TO:Laramie County Board of CommissionersFROM:Marissa Pomerleau, Associate PlannerDATE:June 7, 2022TITLE:PUBLIC HEARING regarding a Zone Change from A2 to AR and a
Subdivision Permit & Pat for Four Mile Meadows Subdivision, 3rd Filing for
a portion of the E1/2 NW1/4 Section 17, T.14N., R.65W., of the 6th P.M.,
Laramie County, WY.

Four Mile Meadows Subdivision, 3rd Filing Zone Change

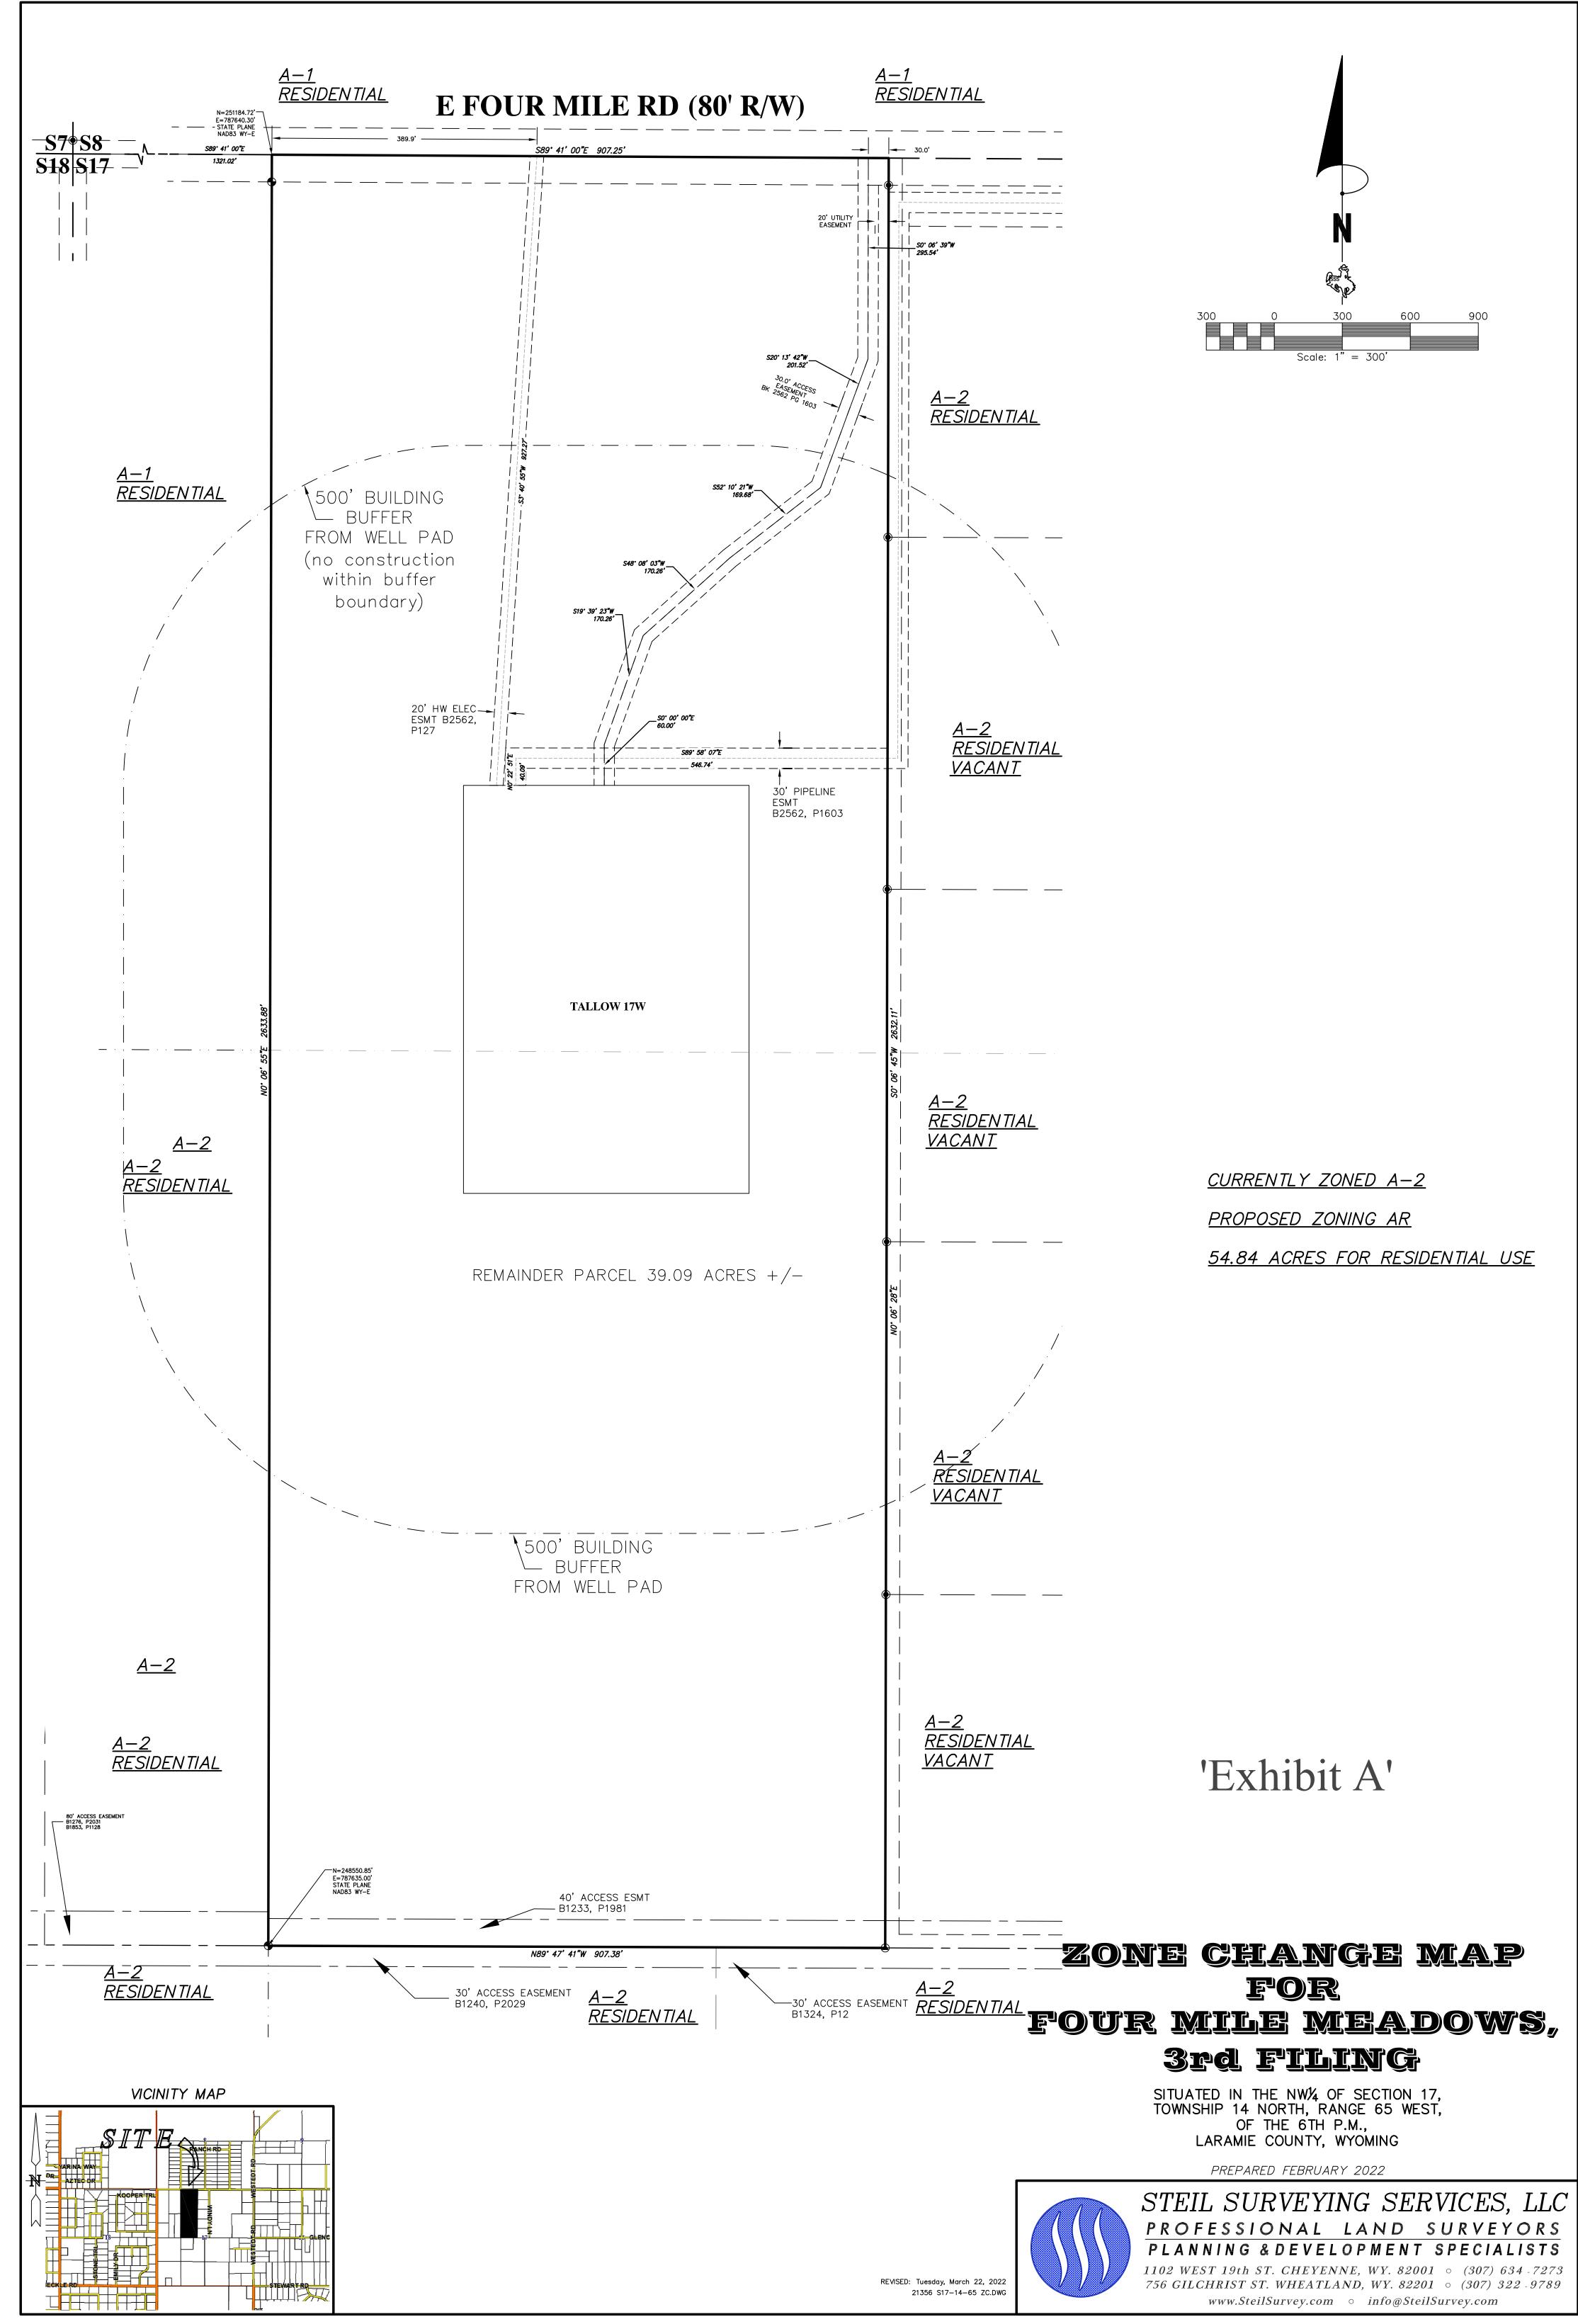
1. The tracts that are proposed with the Four Mile Meadows Subdivision, 3rd filing do not exist yet. Therefore the zone change map should not show the three tracts, but rather how it currently exists.

2. Please remove the vegetation shown on the map.

3. Please add "of the 6th P.M." to the legal description after the township and range.

4. Please remove the dedication.

5. Please remove the notes at the top of the map as they are not needed for a zone change.

6. Please add the surrounding property uses. They are all either residential or residential vacant land.

7. Please remove the filing record space.

8. Please verify overall property dimensions as there appears to be some discrepancies.

Agency review comments were received regarding clerical corrections to the zone change and plat maps, missing information and legibility. Revised zone change and plat maps were submitted to County Planning on May 29th that have addressed all review comments.

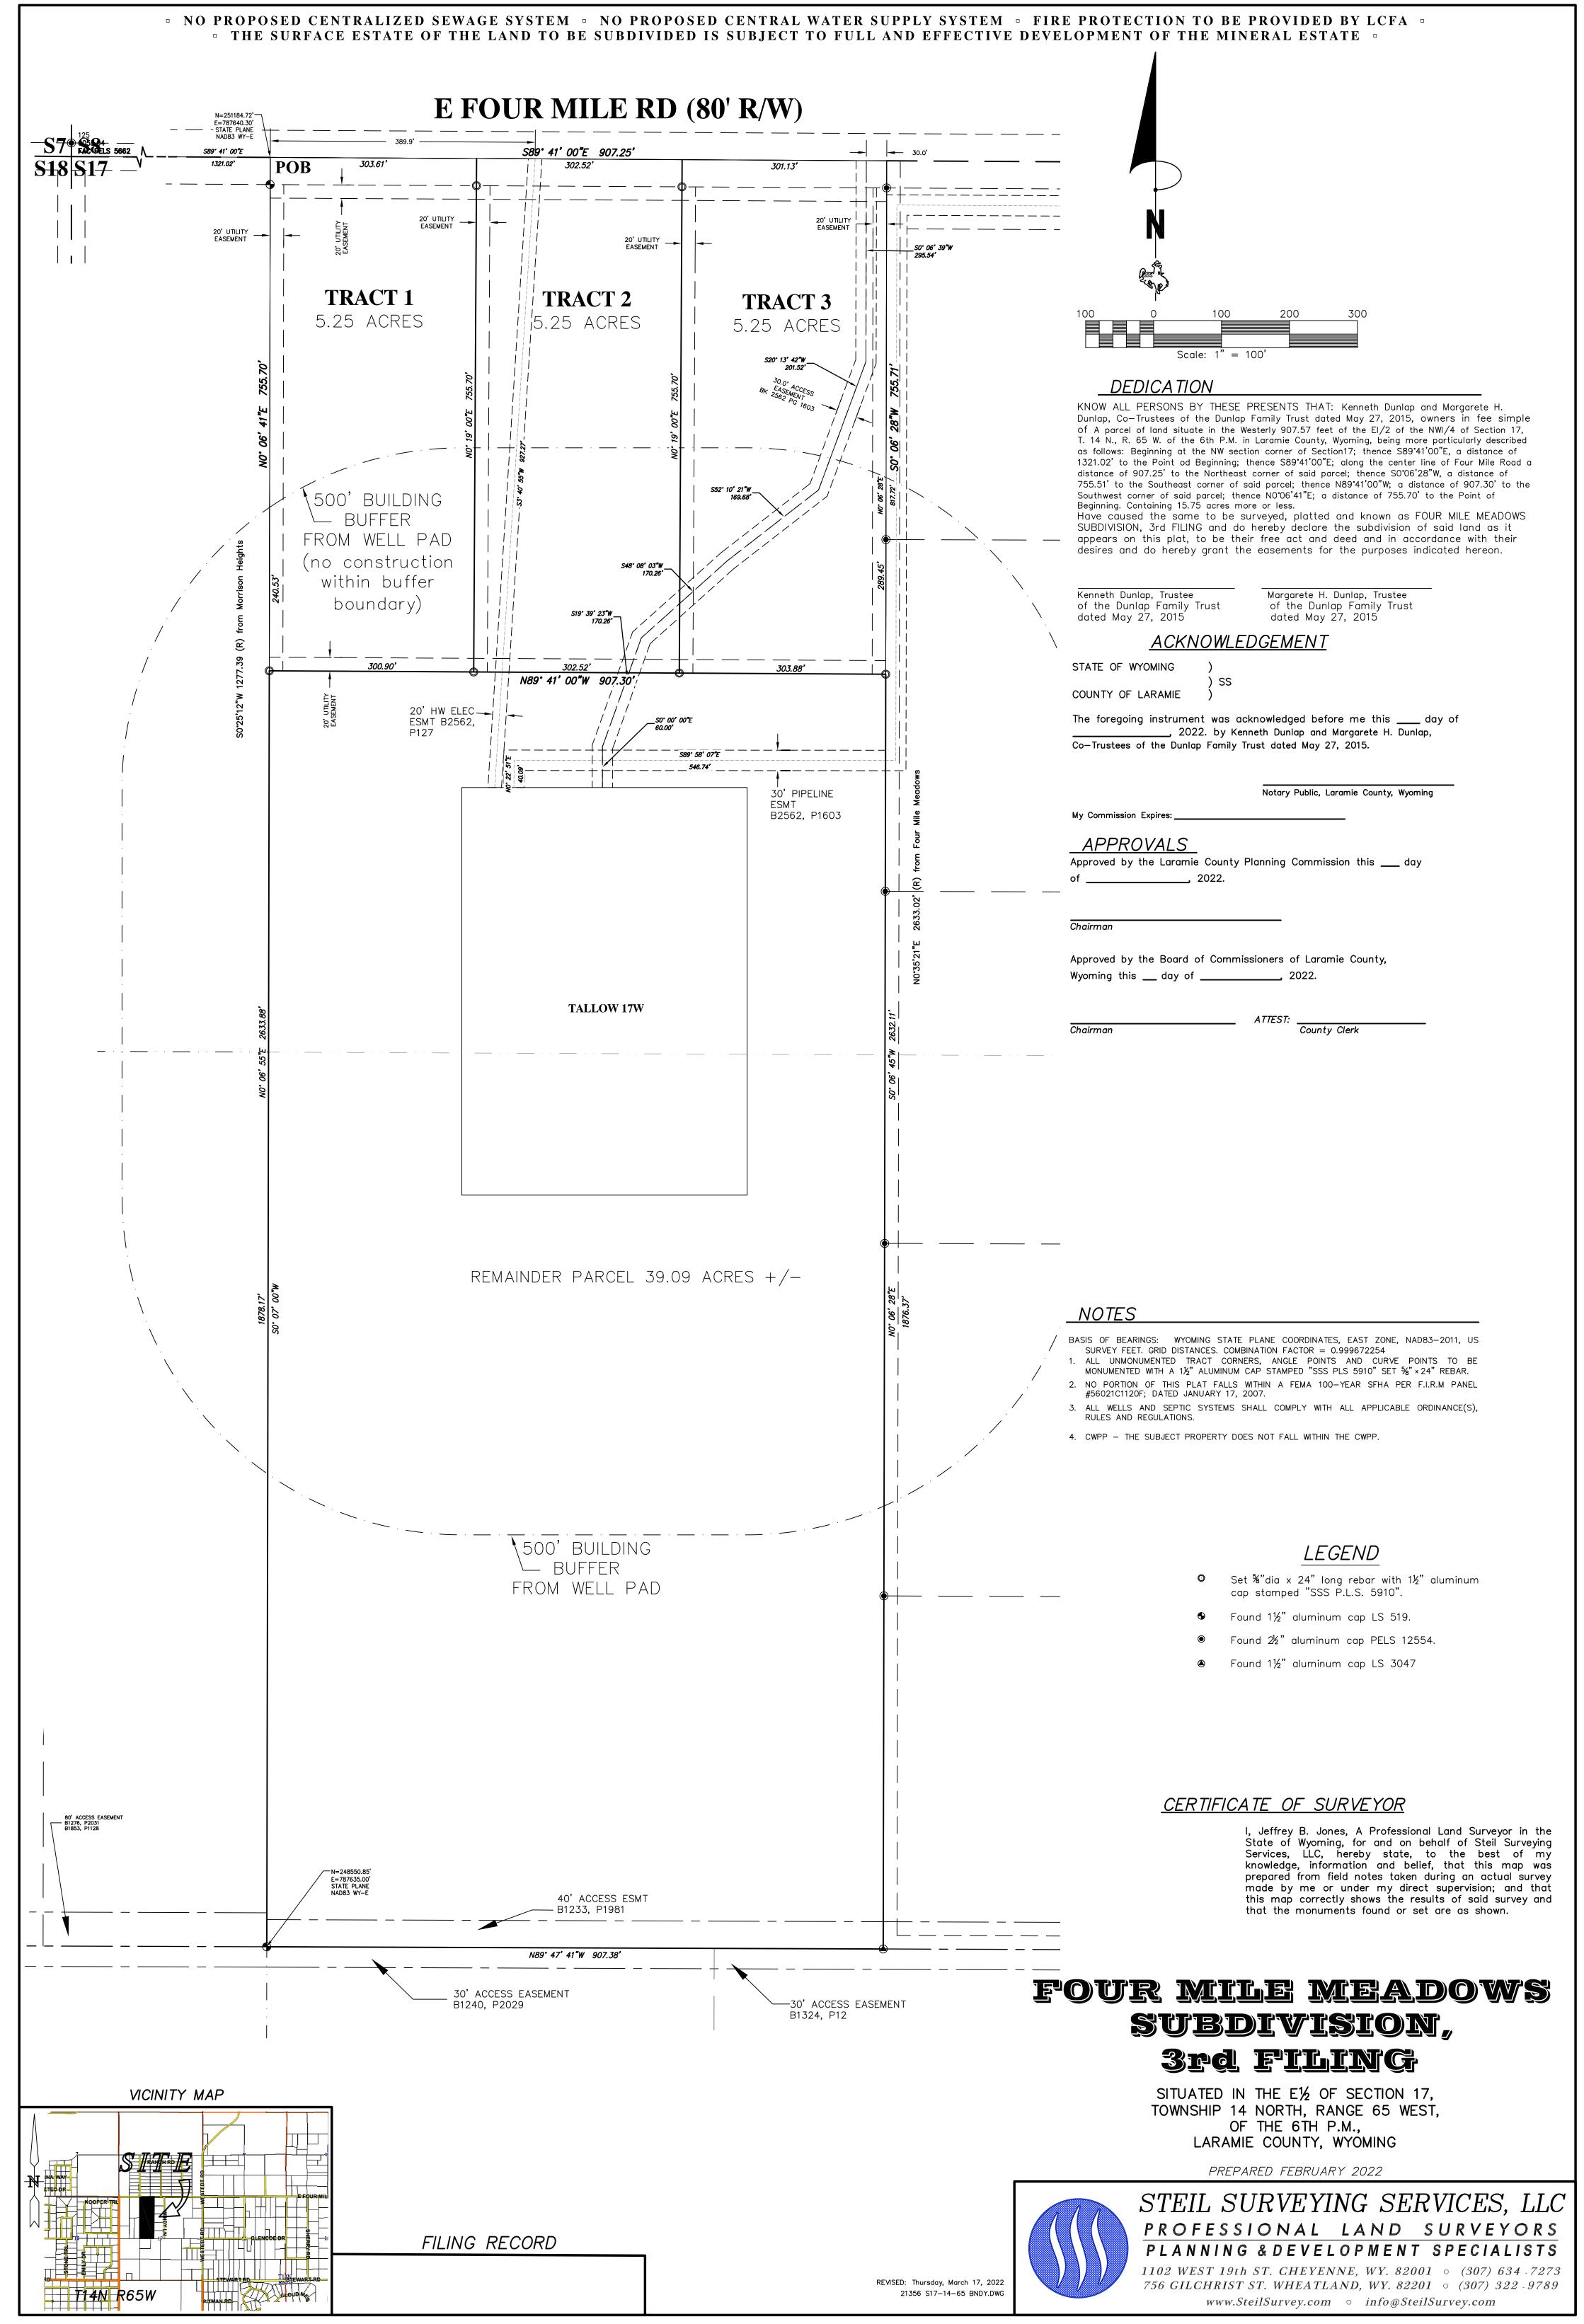
2. It appears the scale on the plat is incorrect. I believe it should be 1"=100' instead of 1"=300'.

3. There is no note regarding the FEMA FIRM panel number/date associated with the platted area.

4. The adjacent property owner's names should not be included on the plat.

5. The basis of bearing is not identified on the plat drawing.

1. The public land survey system corners should be labeled so that they can easily be correlated with the public land survey system ties required on the plat.

2. There are two easements that do not show boundary ties, the 20' HW ELEC ESMT (B2562, P127) and the 30' ACCESS EASEMENT through TRACTS 2 and 3.

3. What exactly are the restrictions of the 500' BUILDING BUFFER FROM WELL PAD? The conditions and/or restrictions should be clearly spelled out on the plat.

4. The names of the streets on the VICINITY MAP are not legible.

5. The Vicinity Map would be easier to read and it would be more useful if one were to add some information such as, at a minimum, the Section, Township and Range data with enough detail to indicate the location of the subdivision within the Section.

1. Add "of the 6th P.M." to the legal description after the township and range.

2. The fire protection must be updated to Laramie County Fire Authority.

4. Update the language that states "Remainder Dunlap Property" to Remainder Parcel and include the acreage of this remainder.

6. The plat does not have basis of bearing/azimuth and survey ties.

8. Please add specific details regarding the 500' building buffer.

9. The correct FEMA Panel with date must be shown on the plat.

10. I assume that the utility easements that board the proposed tracts are proposed, but what about the 30' Access Easement? There is no recordation, book and page information provided. It would be helpful to delineate easements in the legend.

11. As stated in the zone change map review, there appears to be some discrepancies. The remainder parcel shows measurement as 2612.11' on the east boundary and 1878.17' on the west. How is this correct?
